SUNDRY NOTICES AND REPORTS ON WELLS

Merrion Oil & Gas Corporation (14634)

Morgan #6

Merrion Oil and Gas proposes to change the pipeline material submitted in the approved sundry notice dated August 14, 1997 and approved September 18, 1998 (copy attached). We propose to construct the line from polyethylene pipe, Schedule SDR-11, HDS800. The line will be pressure tested with natural gas to 100 psi. All other data provided on the previous sundry will stay the same. Plastic pipe specifications are listed below:

## Morgan No. 6

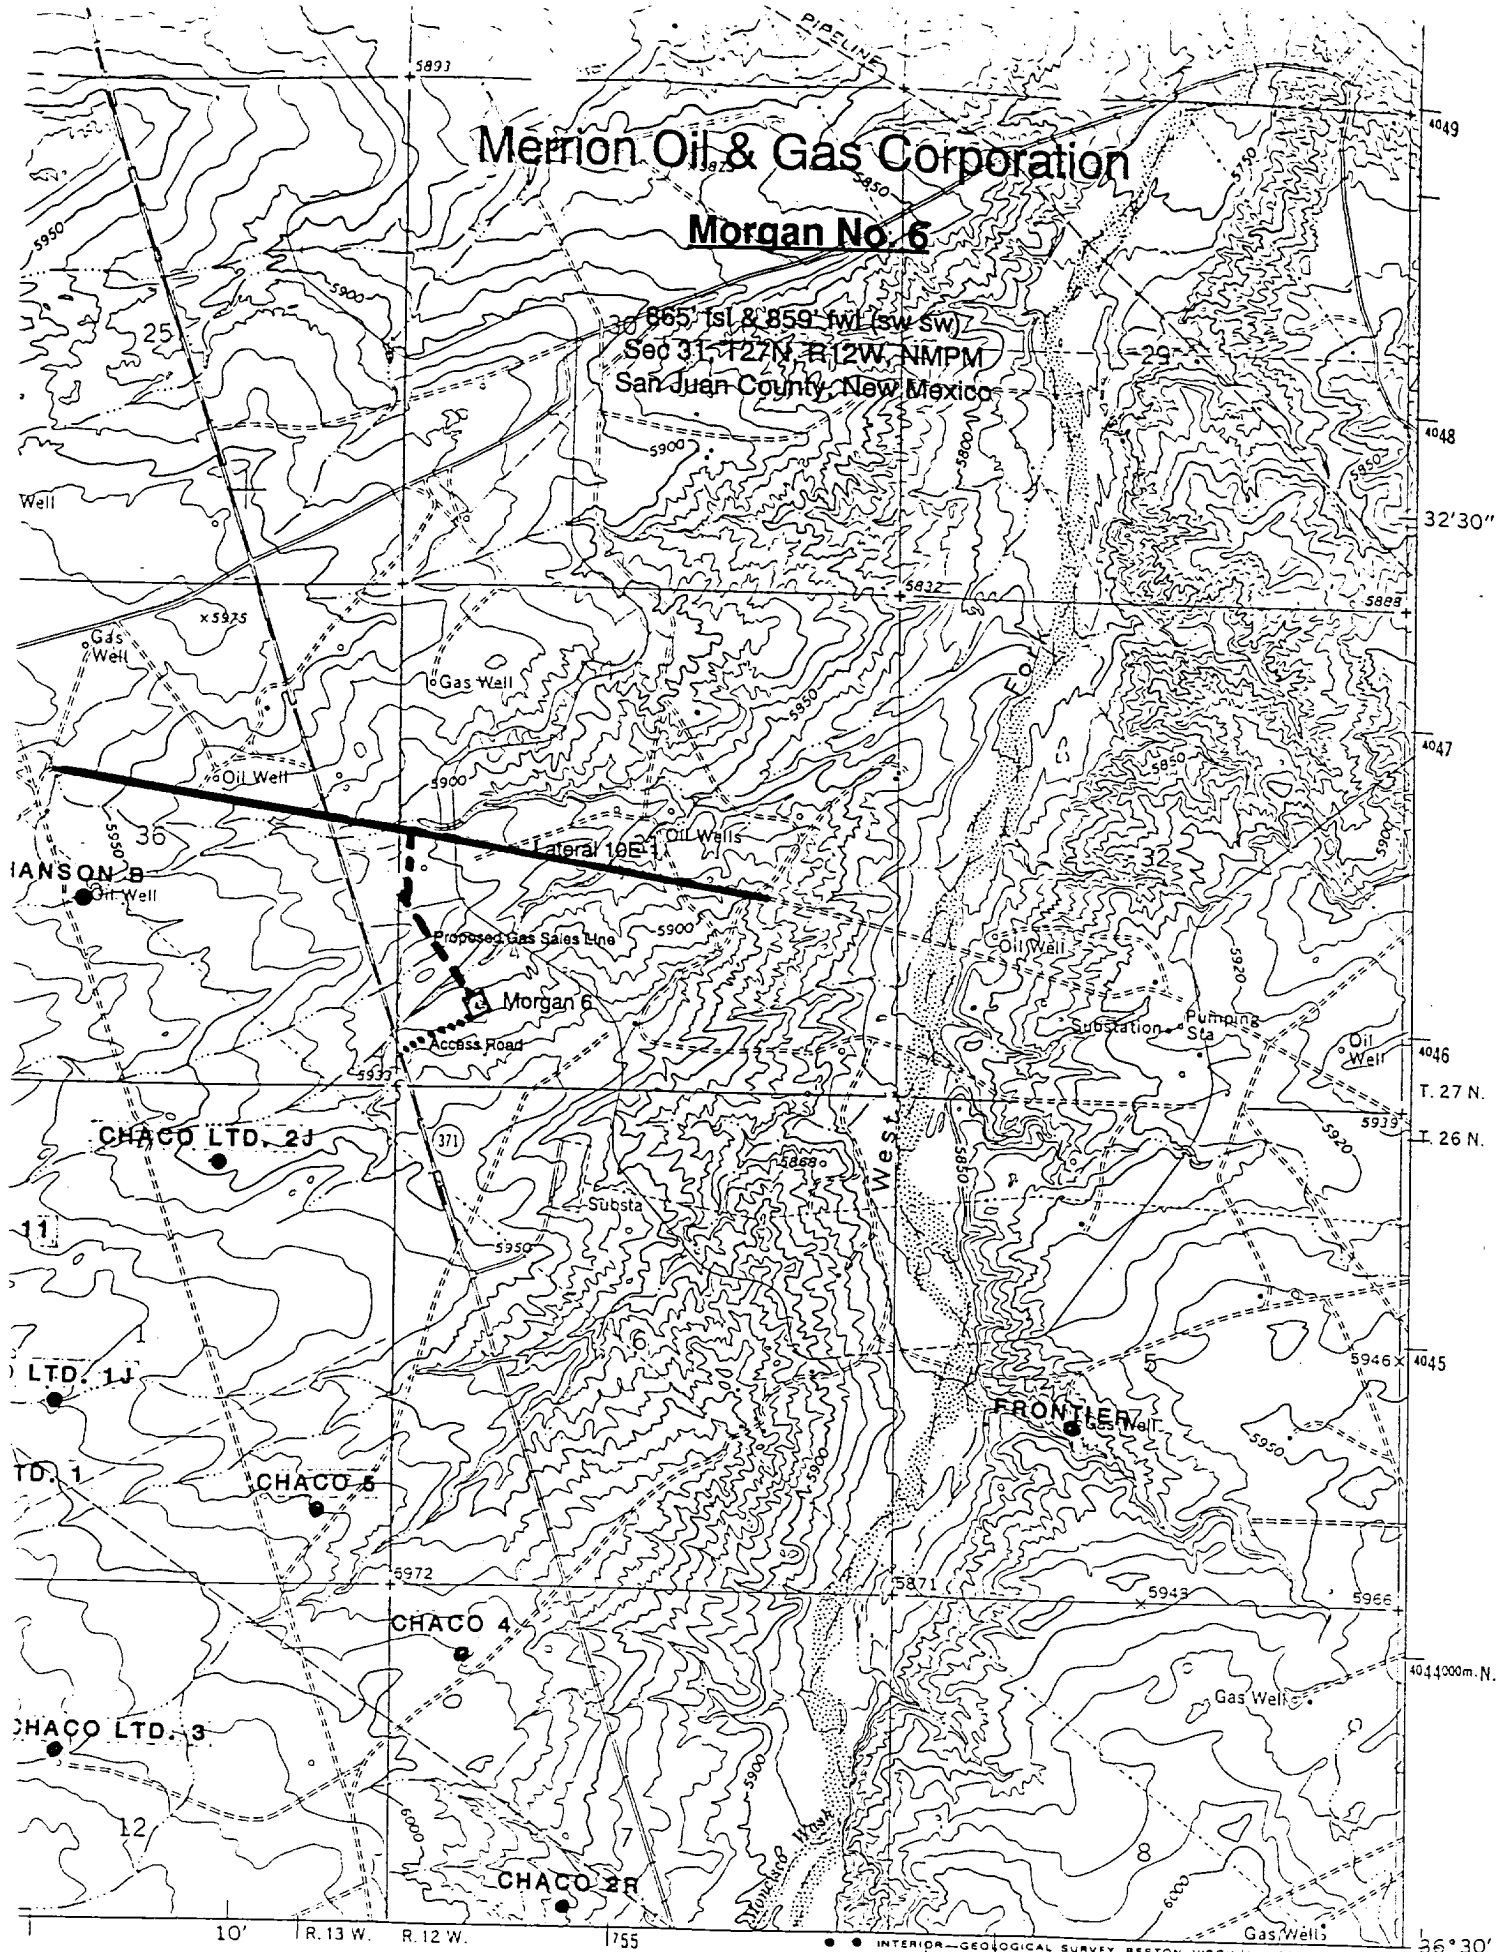
Merrion requests that a gas sales line ROW on-lease be approved as part of the APD process. We have attached a topo map which depicts the route for a gas sales line to the north of the proposed location. We propose to tie-in to EPFS's low pressure system Lateral 10E-1 as shown on the map. This low pressure system has a MAOP of 100 psia; typical operating pressures are in the 40 psi range. The entire route will be located on lease and is about 2100 feet long. The proposed sales line will be buried steel line, either 2-1/2", 3" or 4" depending upon the completion results. Specs for different size lines are included below.
